## Proposed amendment to Appendix 11 to the GCU

<b>Title</b>	Updating the “volumetric capacities” pictogram, in accordance with the EN 15877-1:2012+A1:2018 standard
<b>Proposed amendment made by: RU/keeper/other:</b>	Mercitalia Rail/Sub-working Group Appendix 11
<b>Proposed amendment to:</b>	<input type="checkbox"/> Appendix 9 <input checked="" type="checkbox"/> Appendix 11
<b>Proposer:</b>	Francesco GARRISI – Mercitalia Rail
<b>Location, date:</b>	Florence, 17.01.2023
<b>Concise description:</b>	Give two separate pictograms relating to the volumetric capacity for tank/cask wagons and hopper/box wagons

Figure 41a — Tank and cask wagons

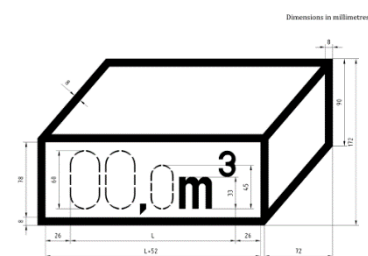
Clause 4.5.16 “Volumetric capacity” of EN 15877-1:2012+A1:2018 (Railway applications – Marking on railway vehicles – Part 1: Freight wagons) provides for two different markings (on pages 56 and 57) regarding tank/cask wagons and hopper/box wagons.

Align the GCU Appendix 11 pictograms and explanations to comply with the standard.

Figure 1

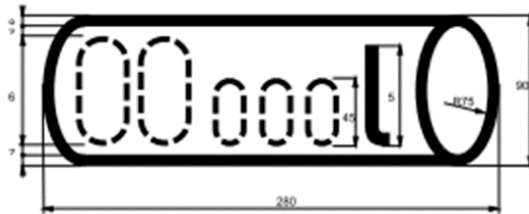
#### 2.7 Signs indicating the volumetric capacity of ~~tank wagons and cask wagons~~ and the type of goods permitted for transport.

**Position:** On the left of each side wall; for tank ~~or battery~~ and cask wagons, on the tank itself or on special boards.

**Meaning:** Capacity in ~~m<sup>3</sup>, hl or l~~

For tank wagons, this sign should also specify the commodities that the vehicle is authorised to carry, if required by the RID for the carriage of dangerous goods

Figure 2

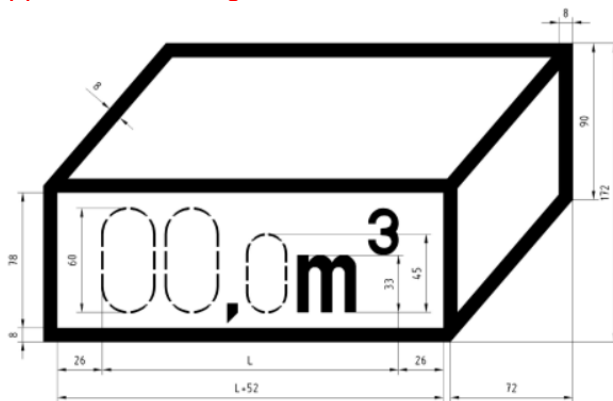
Hopper and box wagons

**Position:** On the left of each side wall; for hopper and box wagons, on the tank itself or on special boards.

**Meaning:** Capacity in m<sup>3</sup> according to the type of wagon

N.B.: if 99.9m<sup>3</sup> are exceeded, add an additional first digit.
